STATE OF NORTH CAROLINA
DEPARTMENT OF TRANSPORTATION

Subject: **Permit Modification Request for the Individual Section 404 Permit and Individual Water Quality Certification** for the proposed widening of SR 1003 (Camden Rd) from NC 59 (Hope Mills Rd) to Owen Drive (SR 1007) in Cumberland County. Federal Aid. No. STP-1003(22), State Project No. 82442601, TIP No. U-2810. Debit \$570 from WBS 34866.1.1

WETLAND /SURFACE WATER PERMIT

Permit Drawing
 Sheet 26 of 26
 APP'D 2-18-11

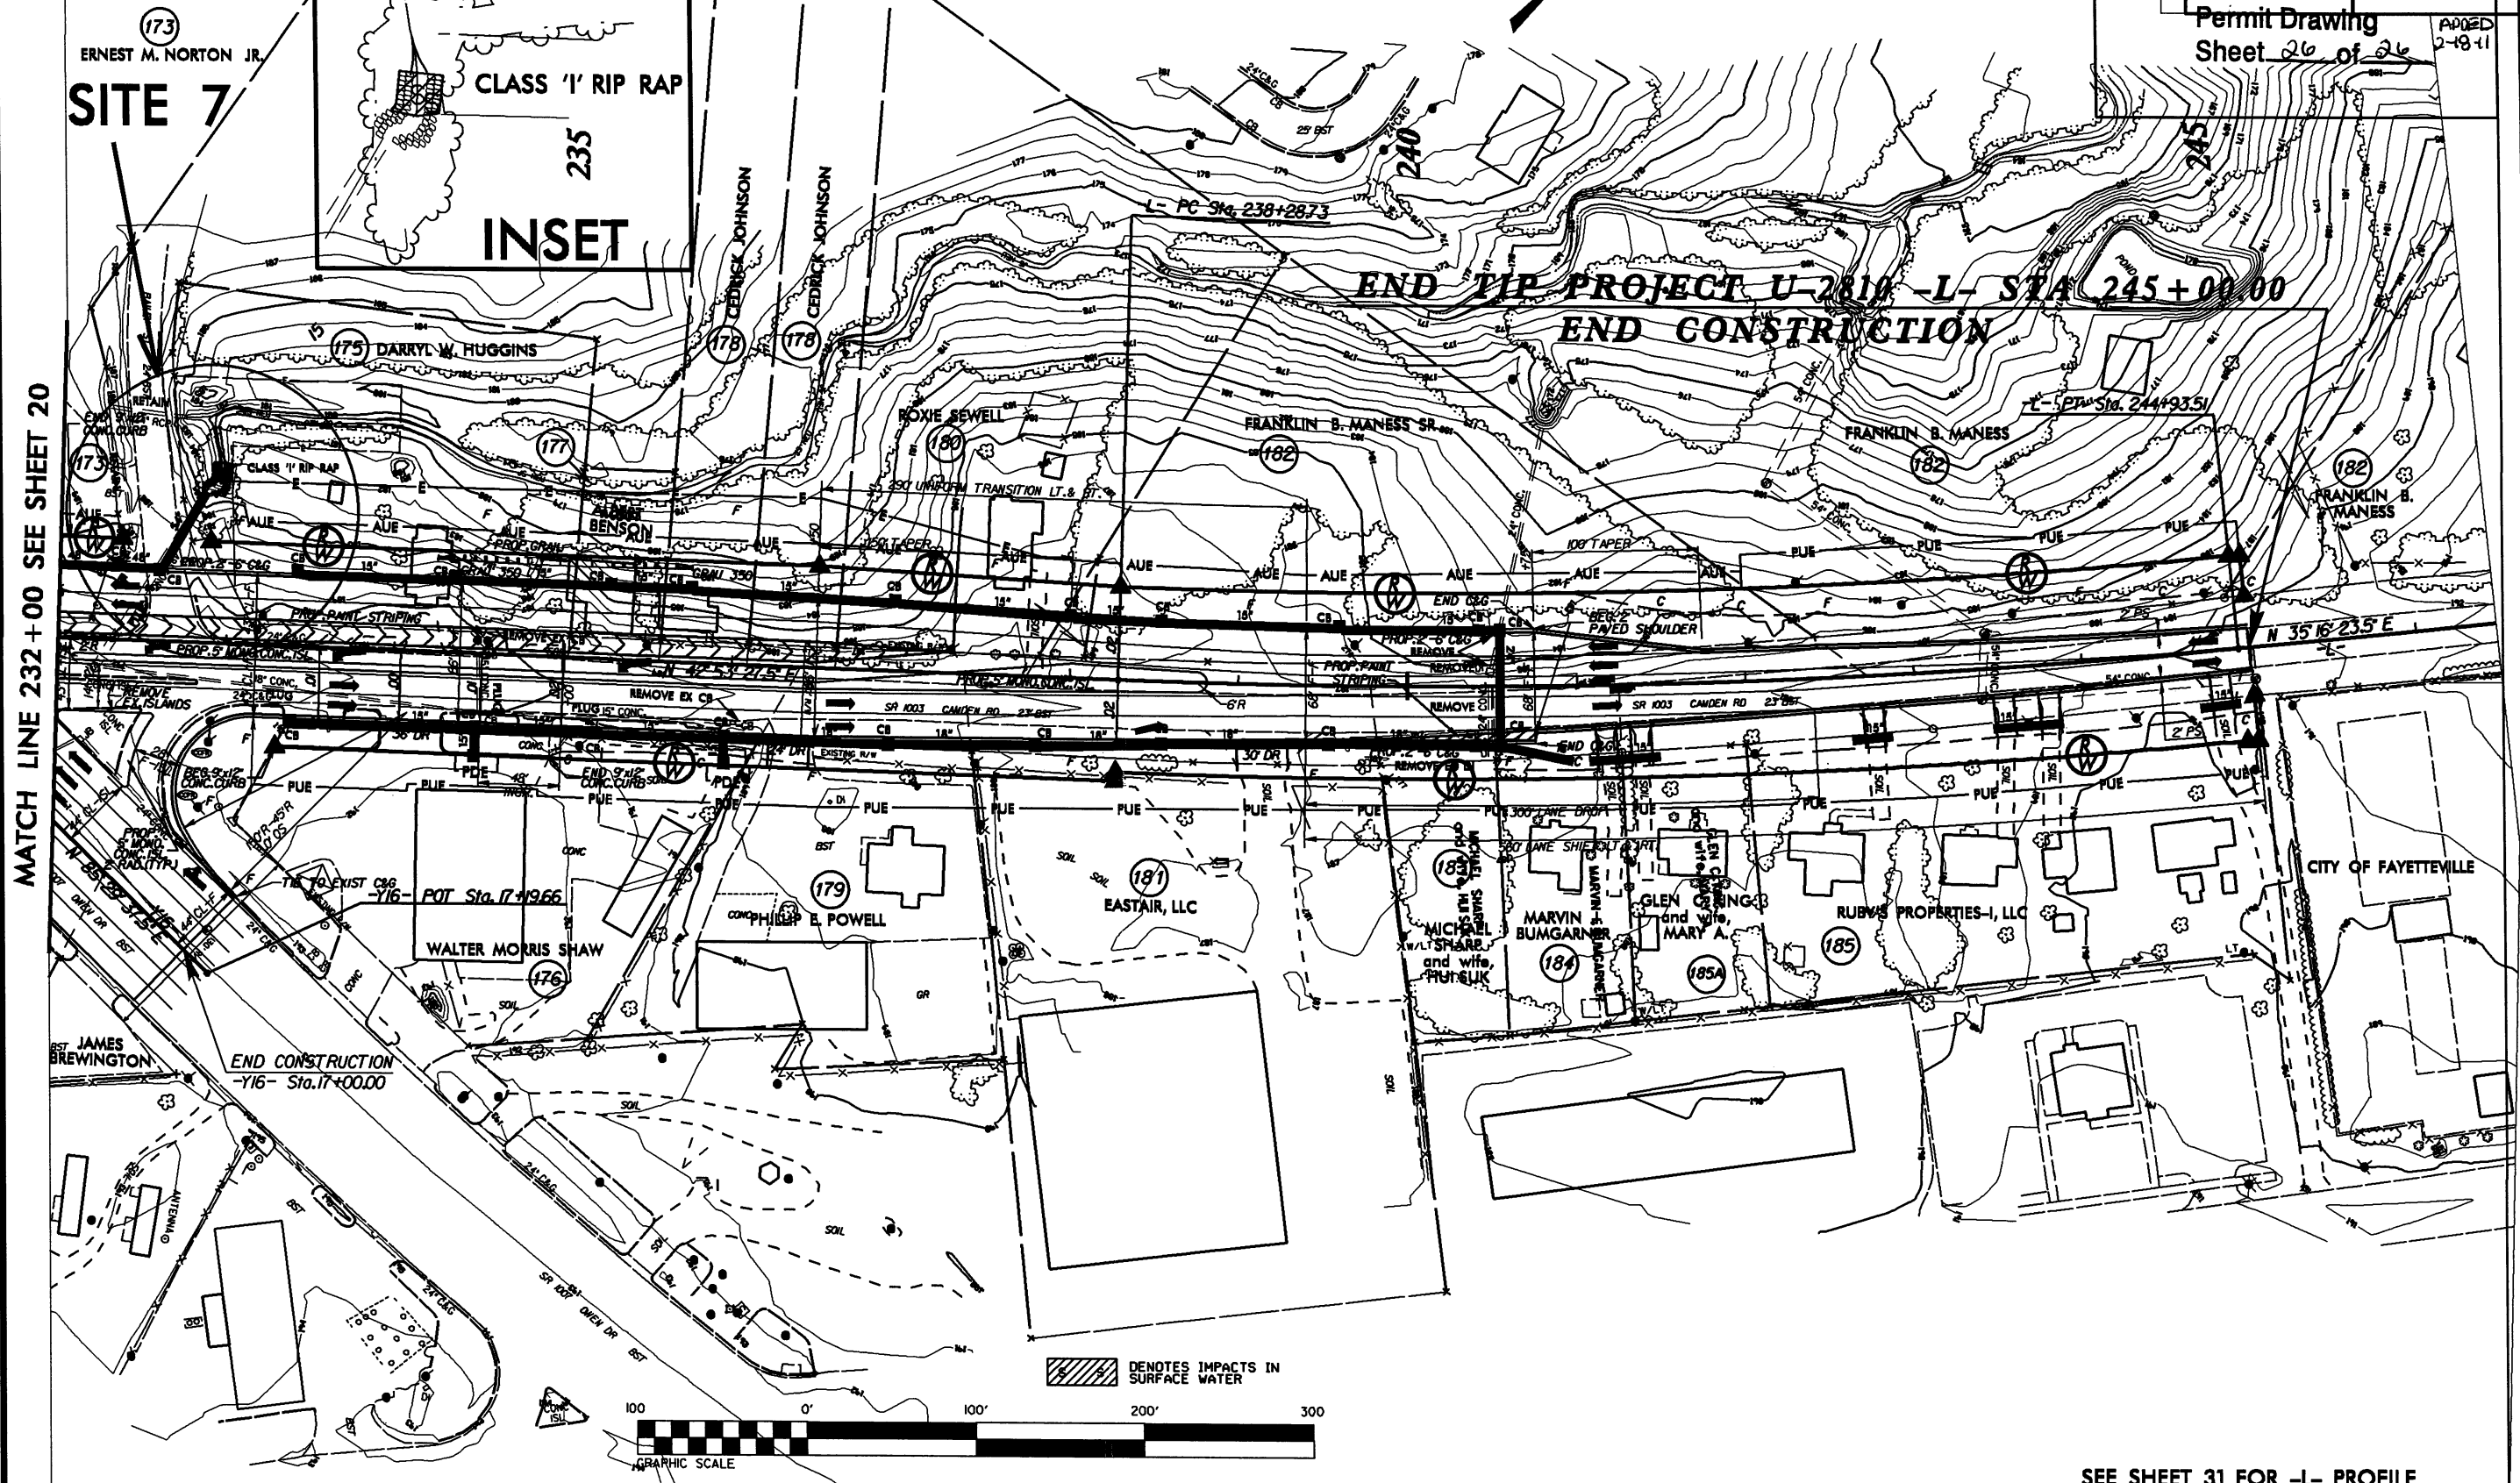
Please see the enclosed revised permit drawings, roadway plan, and revised EEP Acceptance Letter dated February 23, 2011 for the above referenced project. The presence of a stream at site 7 (Sta. 97+36 -L-) on the U-2810 C section was determined after the Jurisdictional Determination (dated November 13, 2003) and the original permit application (dated September 24, 2008). Compensatory mitigation for the additional 11 feet of stream impact will be provided by EEP. A copy of the acceptance letter is included with this request. The additional impacts of 11 feet increases total stream impacts for the entire U-2810 project to 284 linear feet. Wetland impacts remain unchanged at 1.10 acres.

/// DENOTES IMPACTS IN SURFACE WATER
